1. INTRODUCTION

The Port is seeking non-material variations to the project’s Marine Construction Licence in accordance with section 30(7) of the Marine Scotland Act 2010. This document sets out the details of the requested variations and explanation of their non-material nature.

DEEP WATER TERMINAL PROJECT**REQUEST FOR NON MATERIAL VARIATION TO MARINE CONSTRUCTION LICENCE****APPENDIX 1****INDICATIVE DETAILS OF FLOATING LINKSPAN**

REQUEST FOR NON MATERIAL VARIATION TO MARINE CONSTRUCTION LICENCE

Figure 1: Section through indicative floating linkspan

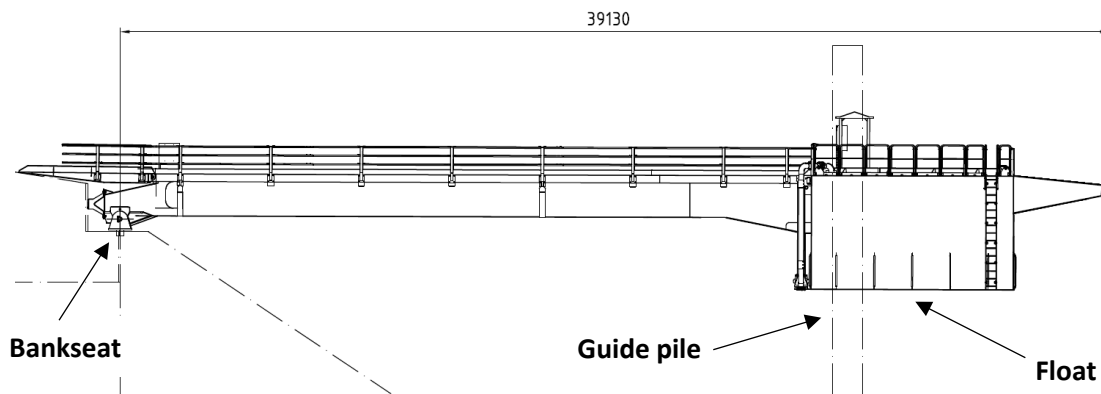
Following contract award, the opportunity to change from a hydraulic to a floating linkspan was identified. Following a thorough examination, the Port identified that a floating linkspan would provide the best value in the long term.

A floating linkspan is connected to the bankseat by means of a hinged connection which allows the ramp to rise and fall with the tide. The weight of the linkspan and the vehicles that use it are supported by a submerged float. The linkspan ramp is secured by means of a guide pile. Figure 1 below shows an indicative section through a floating linkspan. An indicative drawing is provided in Appendix 1. This option therefore means that the linkspan automatically corrects for the tides without the need for major power to control the lifting and lowering mechanisms. The operation of the floating linkspan therefore requires less electrical power than a hydraulic one, thereby reducing carbon emissions. Additionally, there is less risk of pollution as there is no hydraulic fluid in the operating system.

Figure 2: Plan showing consented dolphins for linkspan

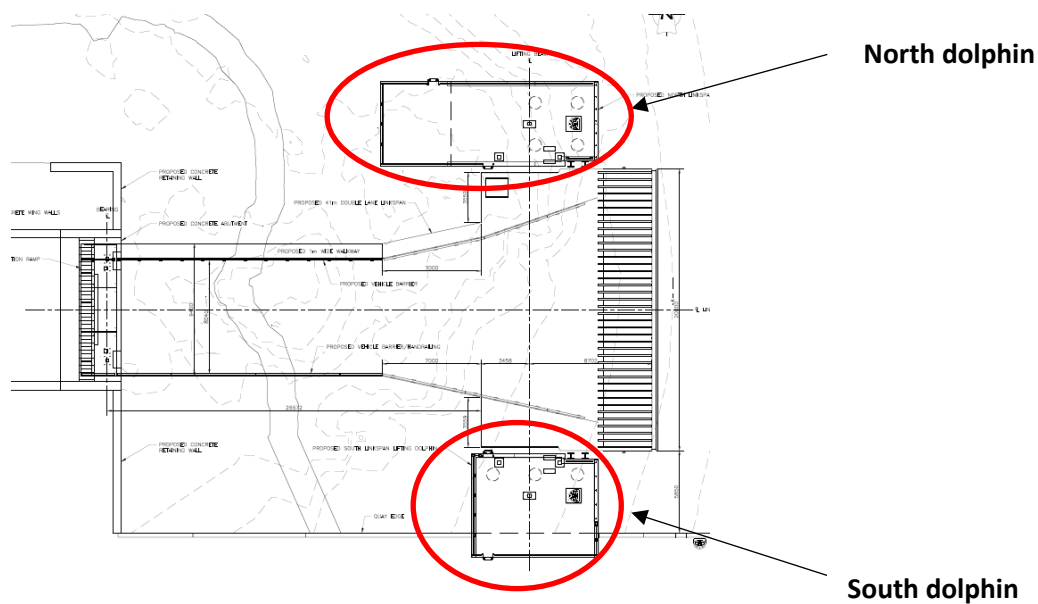
Figure 2 below shows the plan of the consented design, including the two concrete dolphins. Drawings are provided in Appendix 2.

As a result of this design change, the dolphins that would have been required for the hydraulic linkspan are no longer required, reducing the amount of piling, and concrete required; thereby reducing the interaction with the seabed. Details of the omission are given in Section 4 below.

DRAWING TITLE
LINKSPAN GENERAL LAYOUT

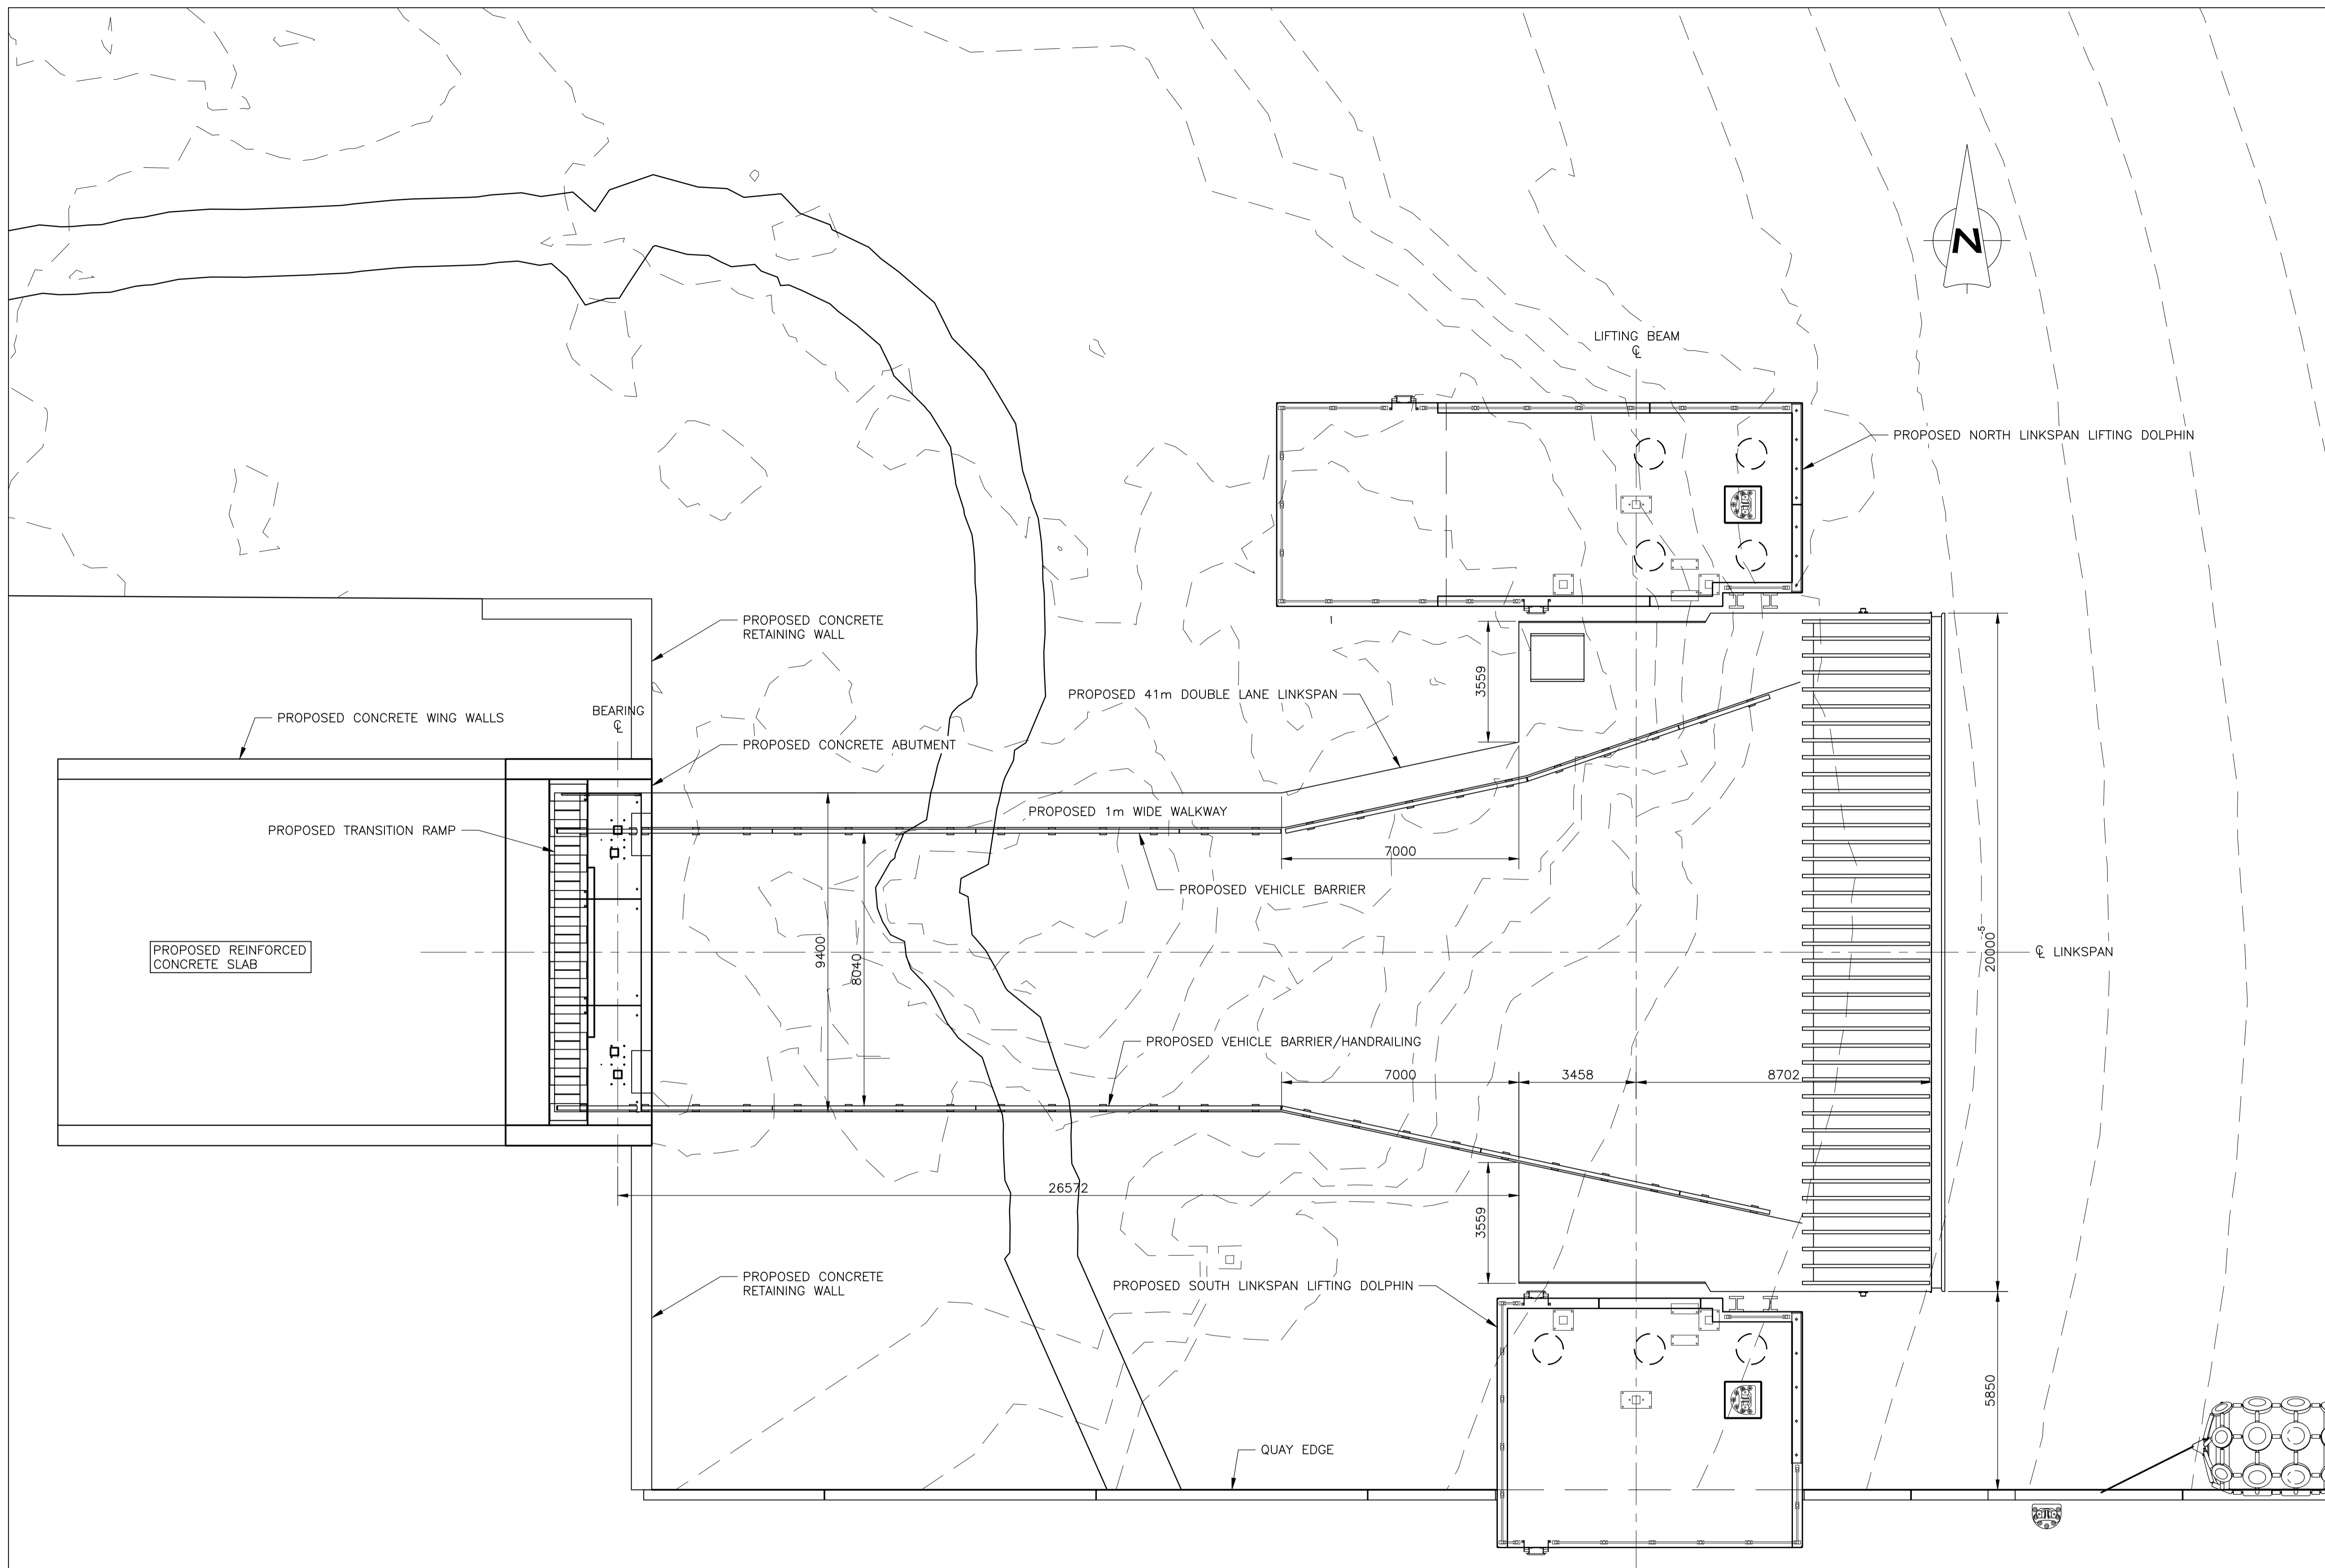
Ref	Item	Description	Materials omitted from works	Comment
1	Linkspan dolphins	2 No. reinforced concrete blocks cast on the seabed supported by steel piles. North dolphin: 15m x 8m in area, supported on 4 No. piles South dolphin: 9m x 7m in area, supported on 3 No. piles. The piles were to be driven to rock by vibrating hammer and	Concrete Steel reinforcement 7 No. 800mm diameter steel piles	Copies of drawings included in Appendix 2
